Product Change Notification

PCN-IFC-8598-2023

Business Unit	Product Line Code	Type of Change	Action	Date of Issue
IFC - Industrial Field Connectivity	BF7	Product Change Notification	Notify Distributors and Field	3/22/2023

If an effort to provide the most complete information available, we are updating the specs printed on the 17pos modular inserts (HC-M-17-CT...).

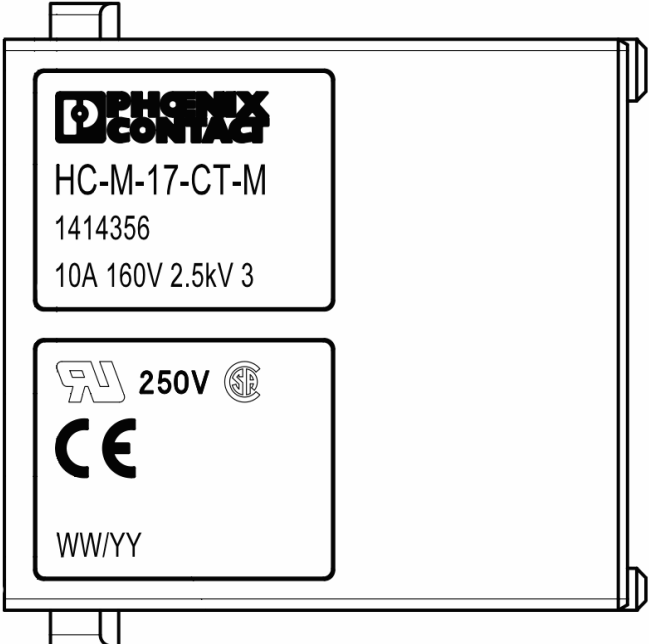
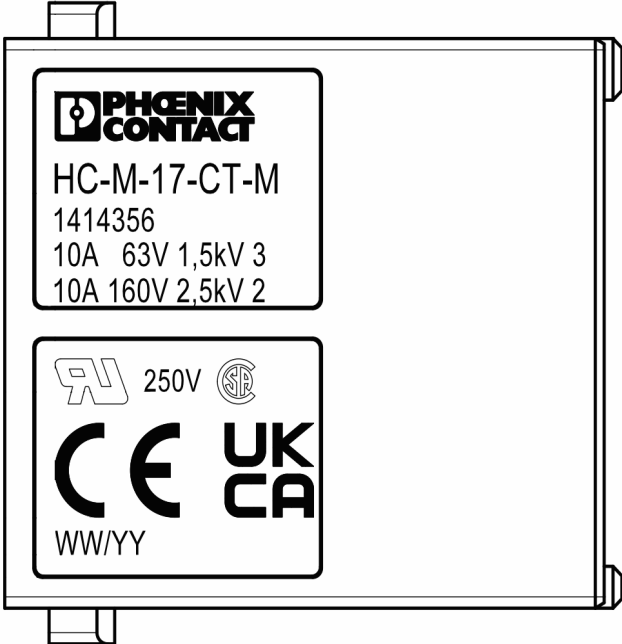
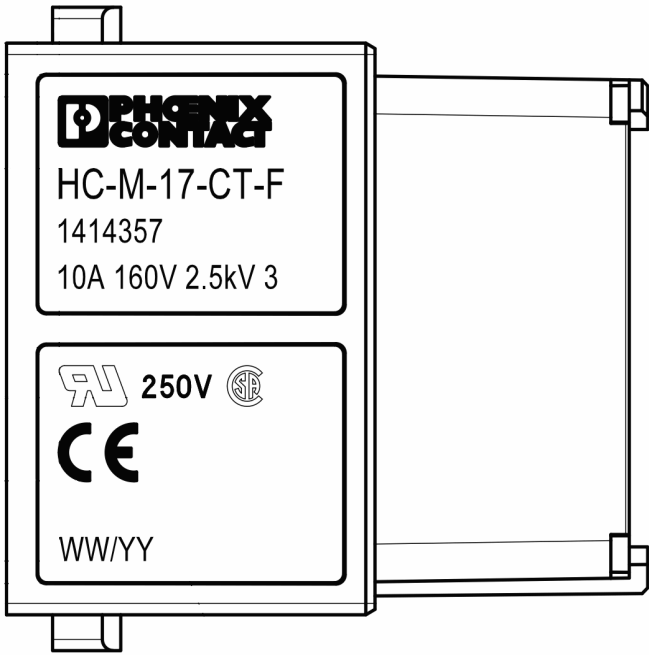
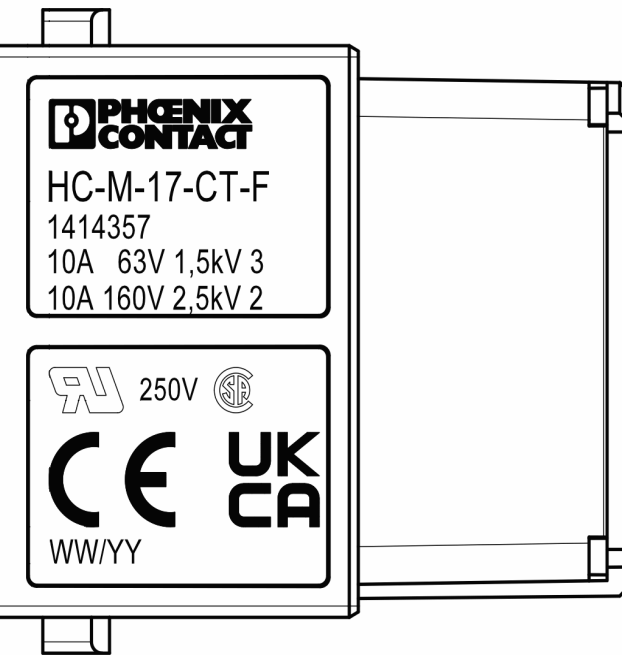
The IEC current and voltage limits for both pollution level 2 and 3 will now be printed on the inserts themselves. Previously only level 3 was included.

Previous Product	New Product
 <p>PHOENIX CONTACT HC-M-17-CT-M 1414356 10A 160V 2.5kV 3</p> <p>250V CE WW/YY</p>	 <p>PHOENIX CONTACT HC-M-17-CT-M 1414356 10A 63V 1,5kV 3 10A 160V 2,5kV 2</p> <p>250V CE UK CA WW/YY</p>
 <p>PHOENIX CONTACT HC-M-17-CT-F 1414357 10A 160V 2.5kV 3</p> <p>250V CE WW/YY</p>	 <p>PHOENIX CONTACT HC-M-17-CT-F 1414357 10A 63V 1,5kV 3 10A 160V 2,5kV 2</p> <p>250V CE UK CA WW/YY</p>
